Baseline Monitoring Report

Longhorn Riparian Buffer Mitigation Site

DMS Project No. 100114

**Re: Longhorn As-Built / MY0 (DMS Project No. 100114)
Response to Comments**

Figure 9
Current Condition Plan View

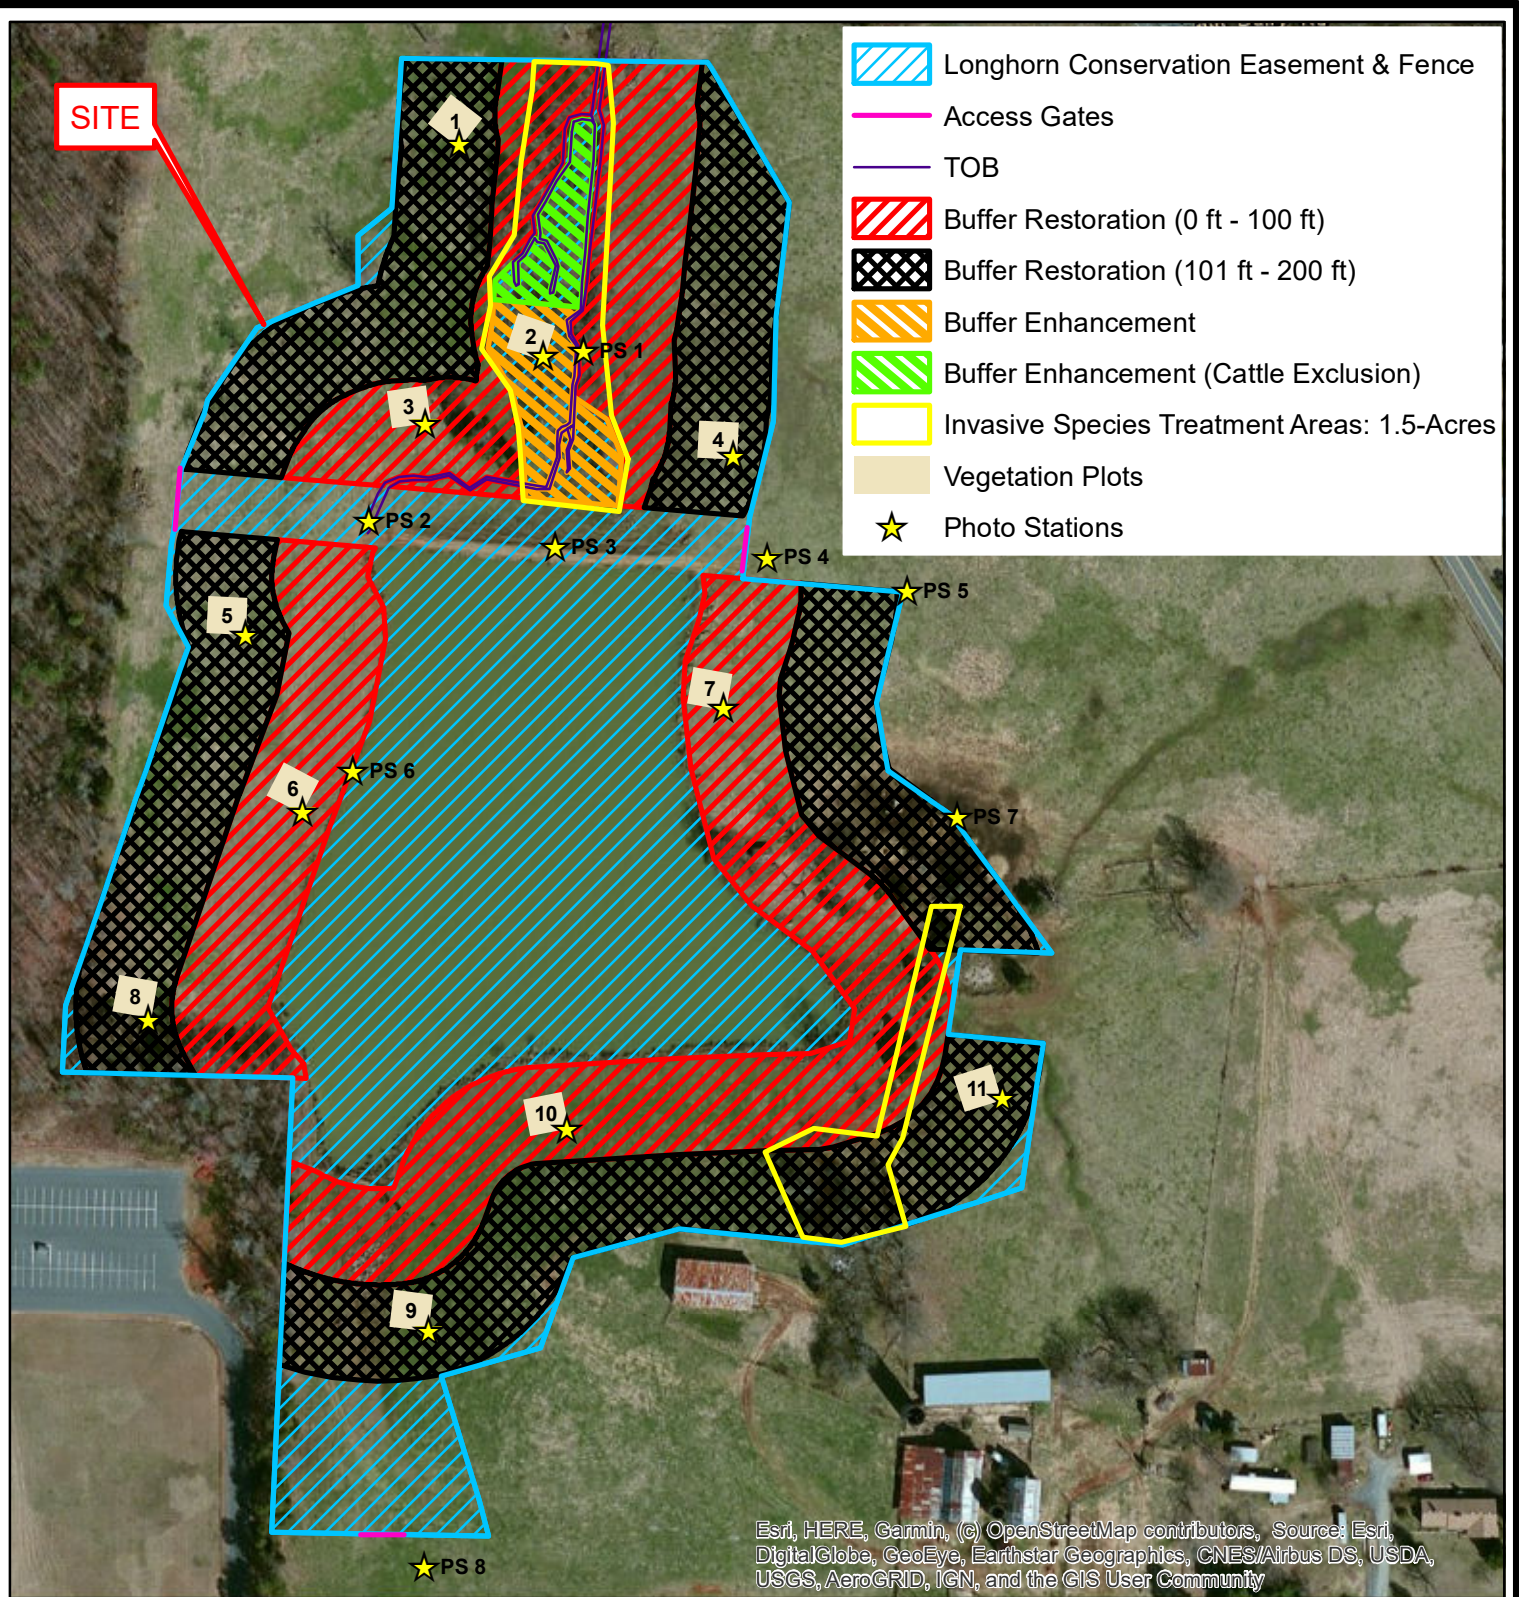
1. Table of Contents – The report only contains a Figure 8, but Figures 8A and 8B are listed.
Please correct.
Re: Corrected.
2. Figure 9 – Please add installed fencing to this map.
Re: Installed fencing has been added to Figure 9.
